ASSESSMENT REPORT

ANGUS PLACE COLLIERY

Ventilation Facilities and Trial Mining Modification (06_0021 MOD 2)

Figure 6: *Persoonia hindii* – Local Population

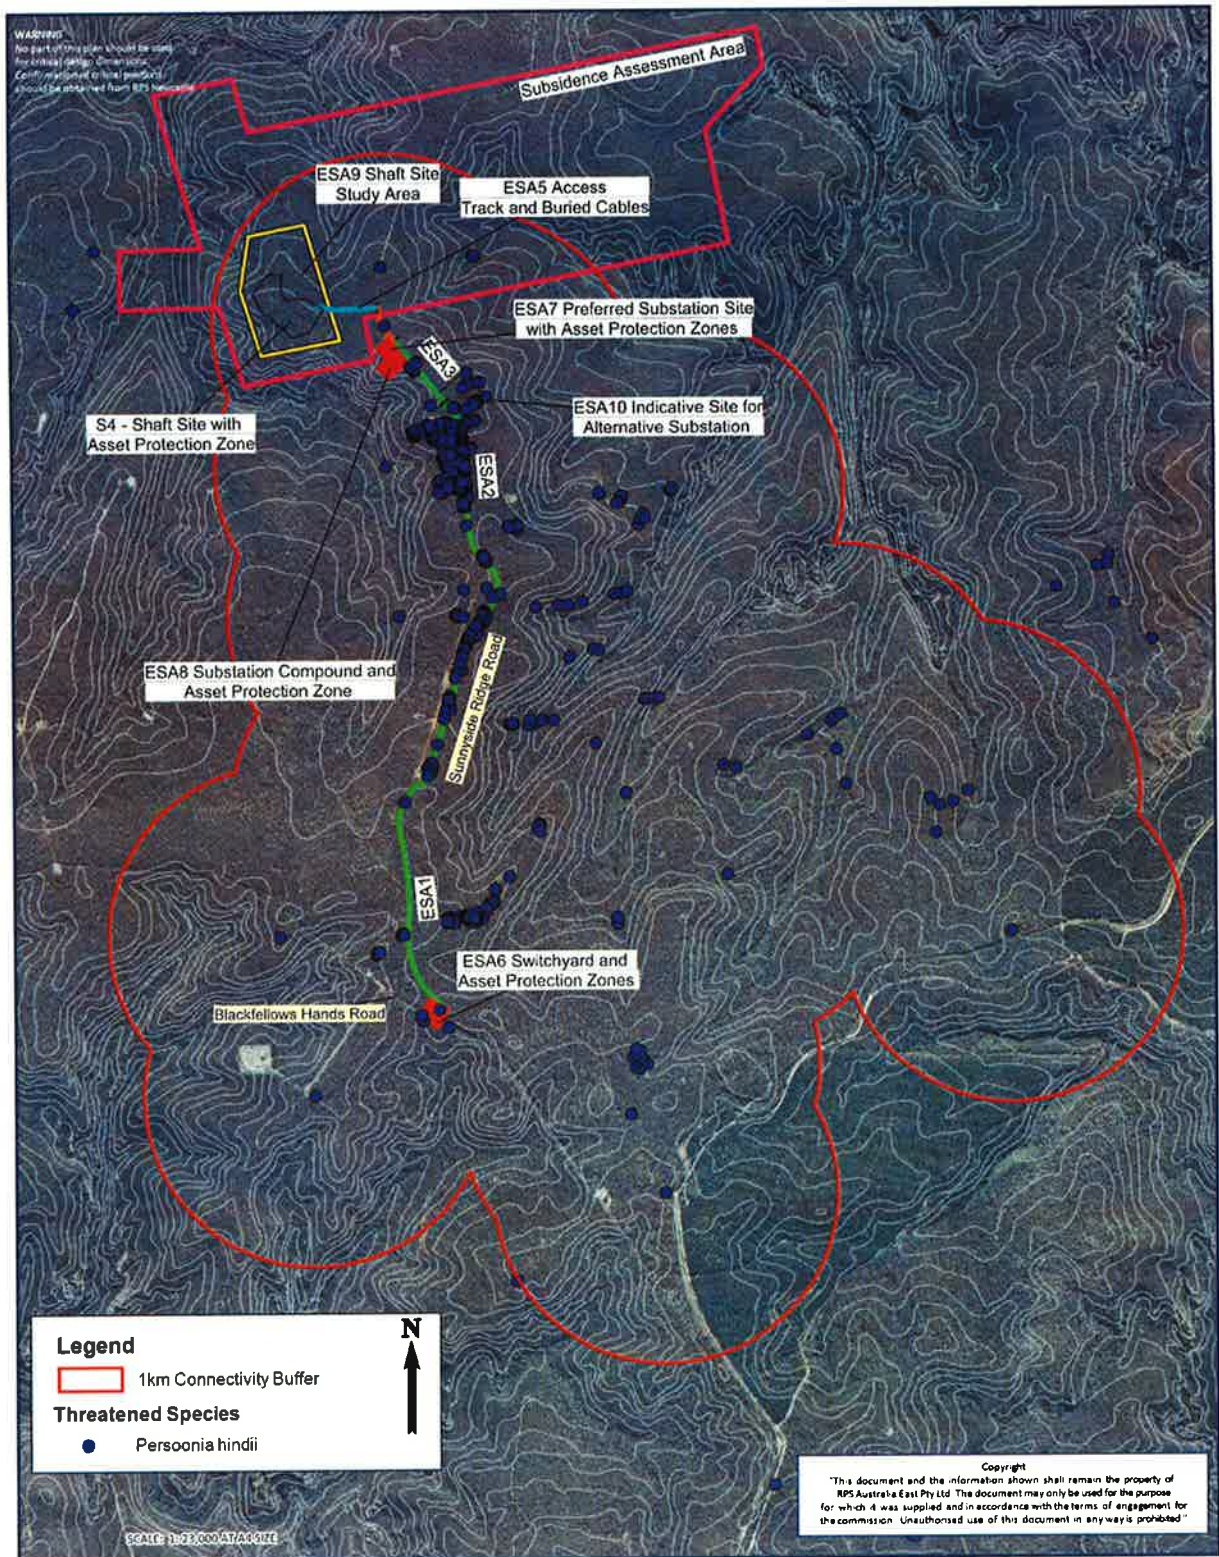
The Department supports all of Centennial's proposed actions. These would, over time, provide detail on the distribution of this plant and just how fragile or resilient it is to impacts such as those associated with this proposal. However, based on the current level of knowledge, the Department remains concerned about the proposed level of impact (up to 11% of the local population, or 7% of the known population) to an endangered plant about which so little is known. The Department has therefore recommended a condition of approval that requires Springvale Coal to produce, implement and fund a

Persoonia hindii Management and Research Program in consultation with OEH and Forests NSW. This program must include:

- surveys and mapping of *Persoonia hindii* across the Newnes Plateau;
- translocation of all stems of *Persoonia hindii* found in the area of disturbance to a nearby area with similar physical and biological habitat features;

Figure 9: Originally Proposed "Indicative" Trial Mine Workings

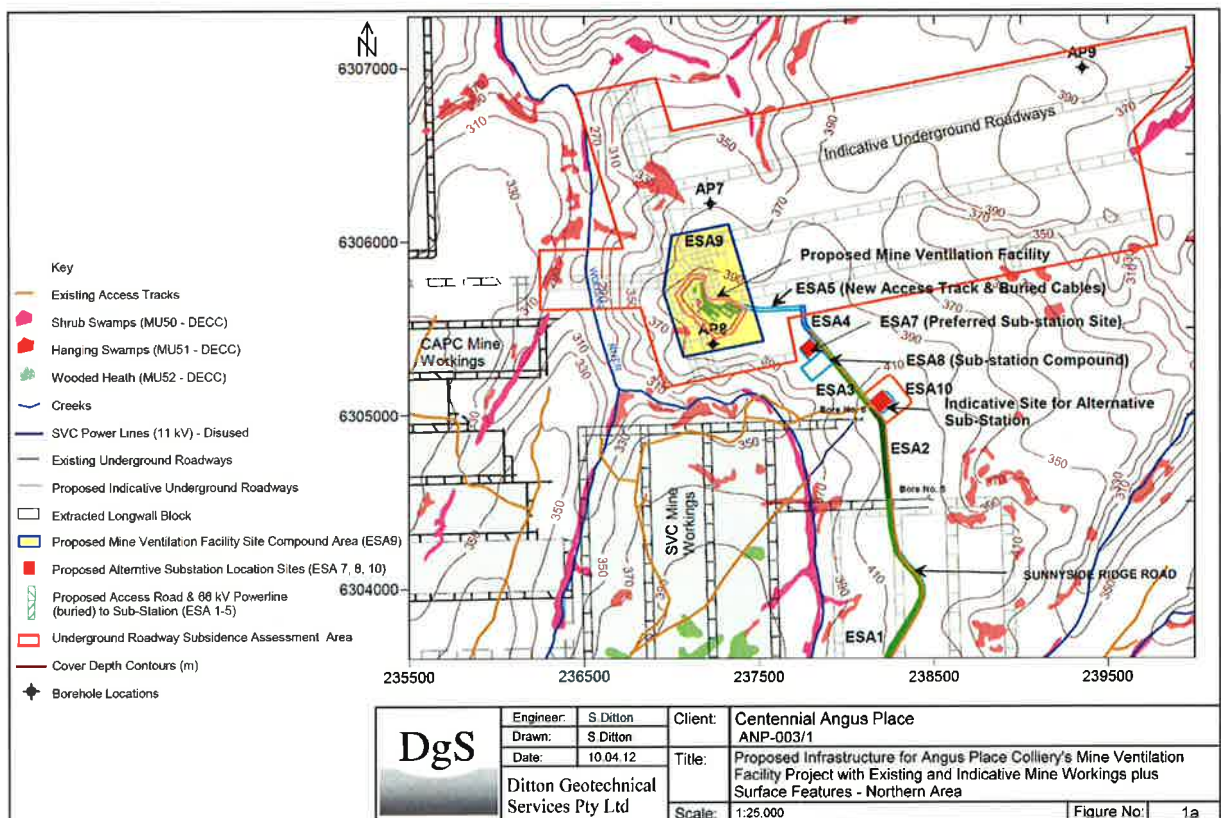
As can be seen, parts of the originally proposed trial mining (in particular the 5 sets of easterly twin headings) have the potential to establish a mining layout for four longwall panels that could then become part of the proposed Angus Place Extension Project, for which Director-General's requirements were issued on 6 November 2012.

If this was to be the case, then this part of the longwall layout, and the associated subsidence impacts on surface features, would effectively become a foregone conclusion. As CFW stated, if this element of the proposed trial mining is approved, then it would effectively “lock-in” the width of these longwall panels. Consequently, any future assessment would not have effective means to control subsidence impacts, for example by requiring narrower longwall panels. CFW and OEH both expressed concerns over this potential outcome, and considered that the most appropriate timing for environmental impact

In respect of the 5 sets of easterly twin headings, the Department shares this position. There are very substantial limitations on its ability to control the subsidence impacts of longwall mining if the width and general layout of these 4 panels are already established. The Department therefore does not support those components of the trial mining layout that effectively set up a longwall mining layout. However, the Department accepts the proposed development of the north-south mains, the development of headings to connect with the 9 proposed service boreholes, and the proposed connection of the existing mine workings with the proposed ventilation shafts (see Figure 9).

Following discussions, Centennial has accepted this position, and has recently proposed significant changes to its trial mining program (see Figure 10). The result is that only one paired set of easterly headings could be driven, together with a north-south set of headings and the previously-proposed mains. All proposed workings would be first workings only, and would be within the current Angus Place Colliery Holding (ie no new mining lease would be required to be granted).

Figure 10: Currently Proposed Trial Mine Workings

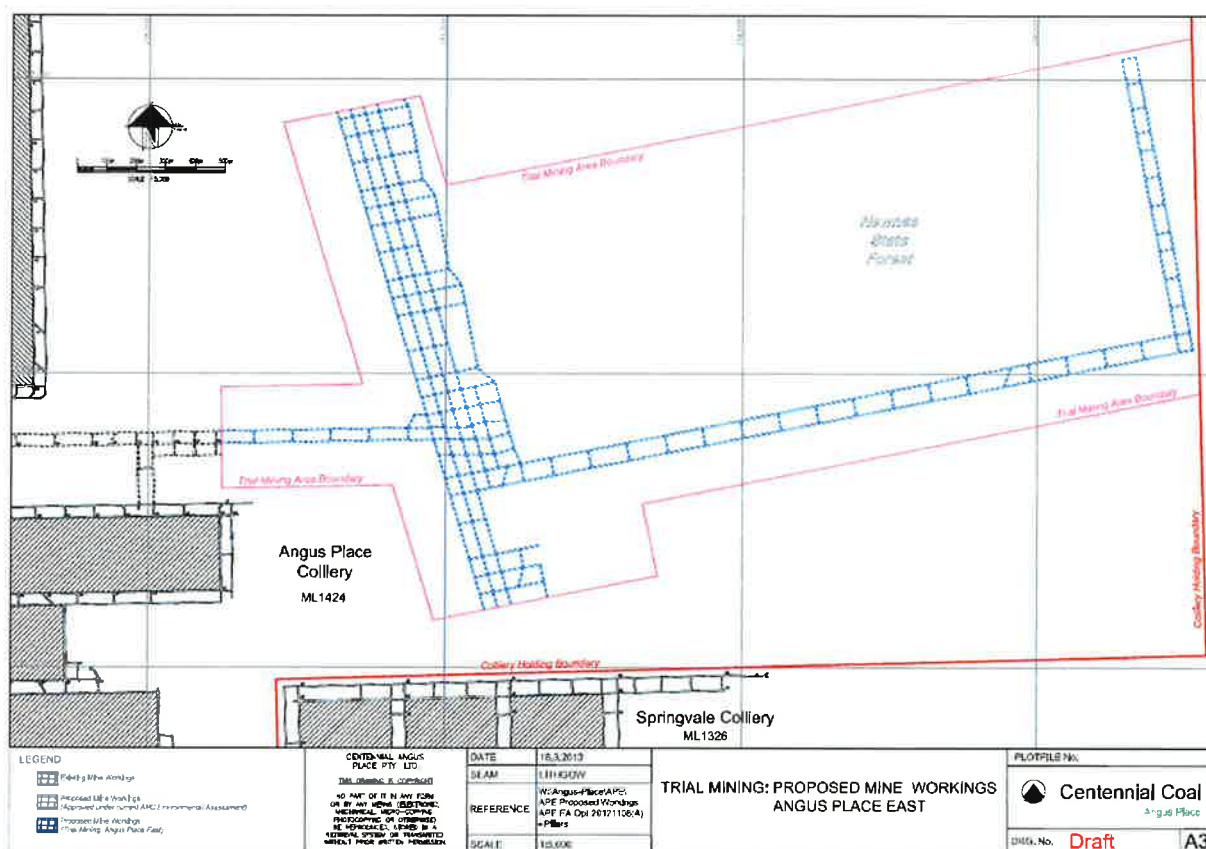
The Department accepts that Centennial has advanced valid reasons to support limited trial mining in the eastern area. A single set of easterly headings, even when coupled with its proposed north-south extension, is insufficient to define the layout of even a single longwall. Subsidence associated with the proposed workings will be effectively zero (ie less than the practical limit of measurability of 20 mm). The information gained would enable Centennial to bring forward a viable proposal for the extension of longwall mining at Angus Place based on superior knowledge but with the flexibility to adjust longwall widths and control environmental impacts.

The Department therefore recommends that Centennial's proposed trial mining is limited to (see Figure 10):

- connection with the existing approved mine workings;
- development of the proposed north and south main headings; and
- development of a single paired set of L-shaped headings east of these mains.
